Re: De Witt Government Center Facility Plan EIR

SUBJECT: DeWitt Government Center Facility Plan EIR

RE: DeWitt Government Center Facility Plan

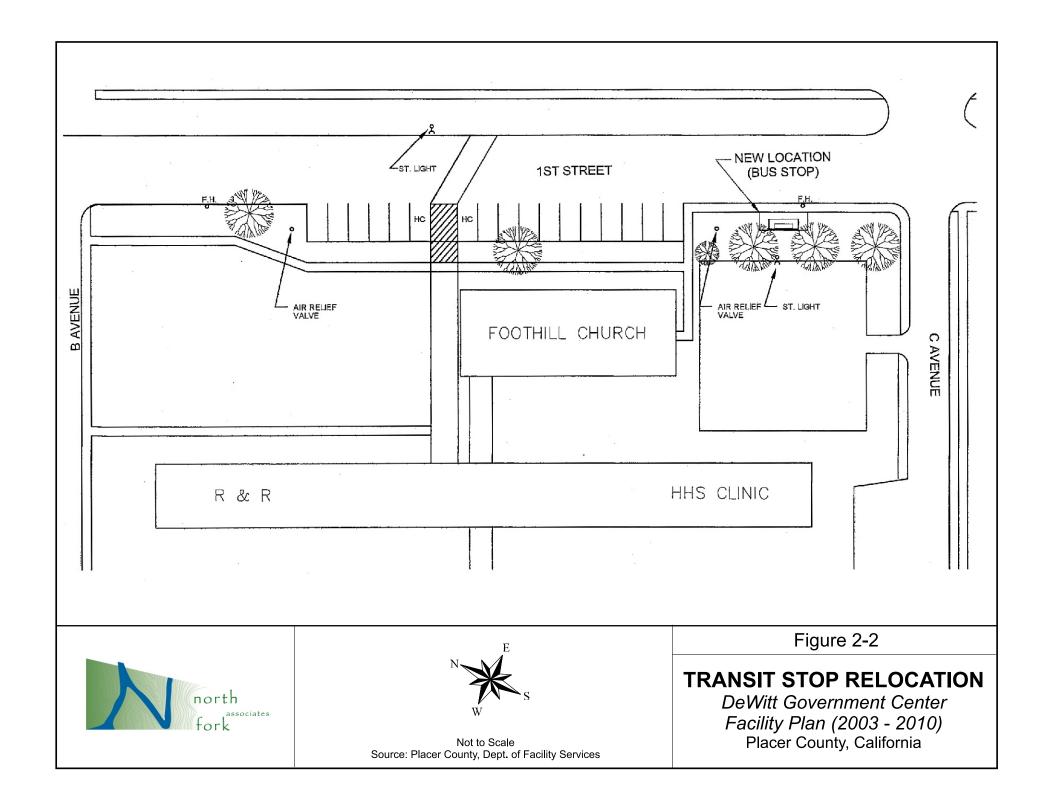
The Public Draft EIR for the DeWitt Government Center Facility Plan does not consider the impact to the A Avenue stop used by Placer County Transit. Currently the Highway 49 Bus route boards an average of 30 passengers per day at this stop. The bus stop location is on the site of the future Land Development Building. The Facility Plan should provide for the relocation of this stop.

F-1. The Public Works Department letter notes the Draft EIR does not consider relocating the Placer County Transit bus stop currently located on A Avenue within the Land Development Building site. The commentor notes that the project should include relocation of the stop, which serves an average of 30 passengers per day.

The Department of Facility Services has identified an appropriate relocation site for this bus stop, approximately 150 yards east of the existing location on First Street at C Avenue. Figure 2-2 of this Final EIR shows the proposed new location and text has been added to page 2-19 of the Draft EIR to include the bus stop relocation in the project description. According to a recent ridership survey conducted by the department, the proposed location is more proximate to the destinations of the majority of transit passengers than the existing location.

The bus stop relocation would include moving the existing passenger shelter to the new location. Site preparation activities would include removal of existing ground cover, pouring a concrete pad, and re-installing the shelter. The concrete pad would be approximately 20 feet wide by 8 feet deep. No tree removal is anticipated in the relocation. The Lead Agency will work with the Department of Public Works to ensure the bus stop relocation meets with typical County standards.
